## SITE PLAN

# INDUSTRIAL BUILDING #29 MAJESTIC COMMERCENTER SUBDIVISION FILING NO. 8

COVER SHEET

MAJESTIC COMMERCENTER  
FILING NO. 8 & 11  
1ST MAJOR AMENDMENT  
AMENDED NOTES

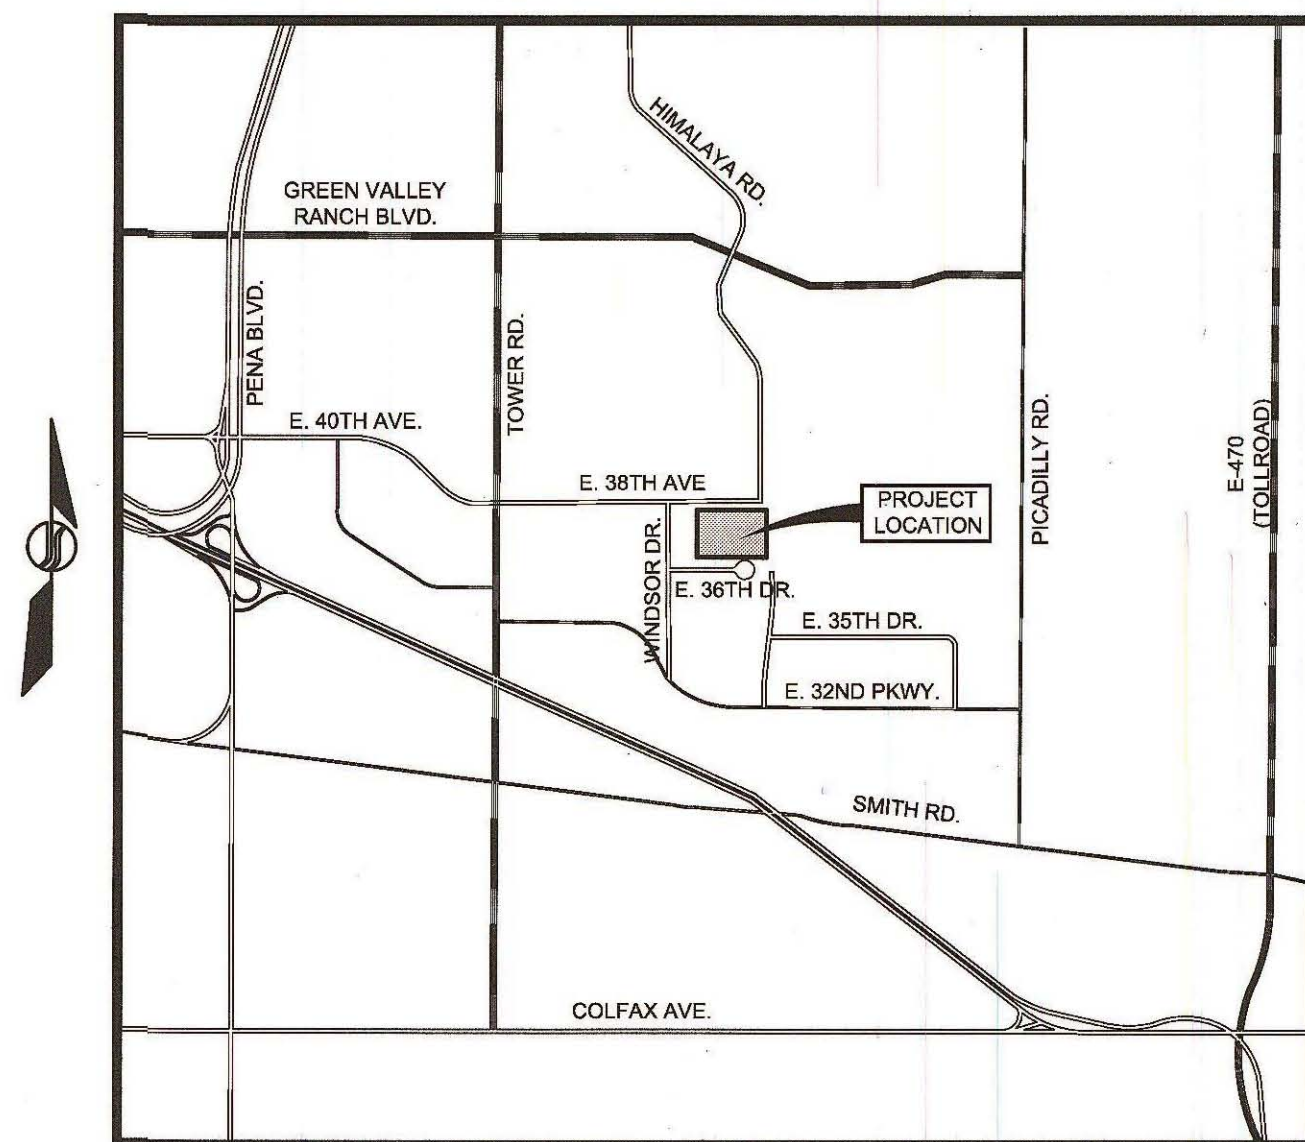
Does not match the plat Filing No. 11?

Filing Number has been revised to match the plat
